MEMORANDUM

DATE: Monday, June 10, 2019
TO: All Bridge Worksheet Users
FROM: Michael Collins, Staff Bridge Branch Manager
SUBJECT: CDOT Bridge Worksheets Additions and Updates

Allowable Value Engineering Dimensions

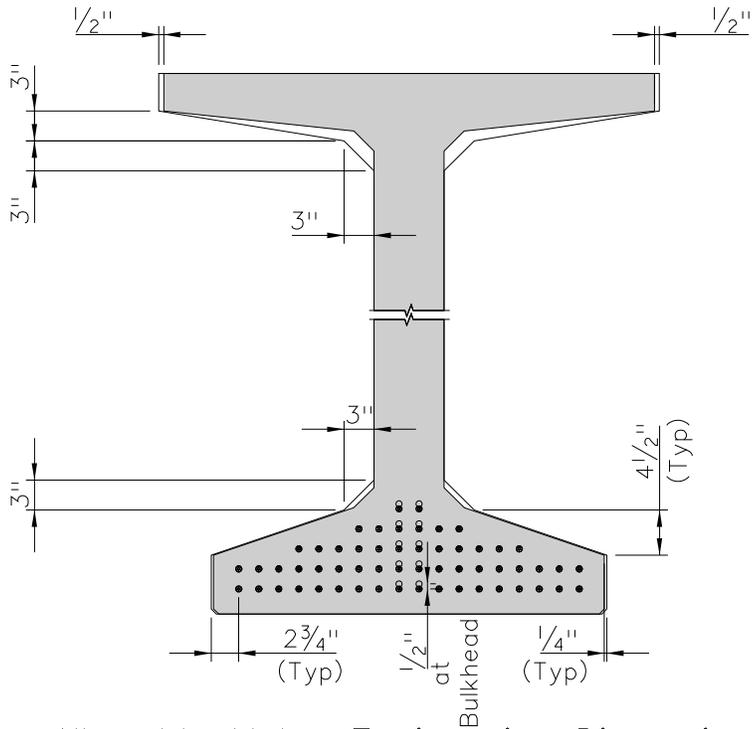
To facilitate the transition of the new forms for the state's fabricators, value engineering or modification of the dimensions shown in the plans will be allowed during the shop drawing process to approximate these shapes utilizing available formwork for two years from the date of this memo (see below). This will necessitate the design engineer to reevaluate the design & rating while reviewing the shop drawings. This evaluation may be done during the design process as well, using the modified CBT dimensions shown. After 2 years the fabricators will need to match the dimensions shown in the worksheets.

See B-618-CBT2 for dimensions not shown
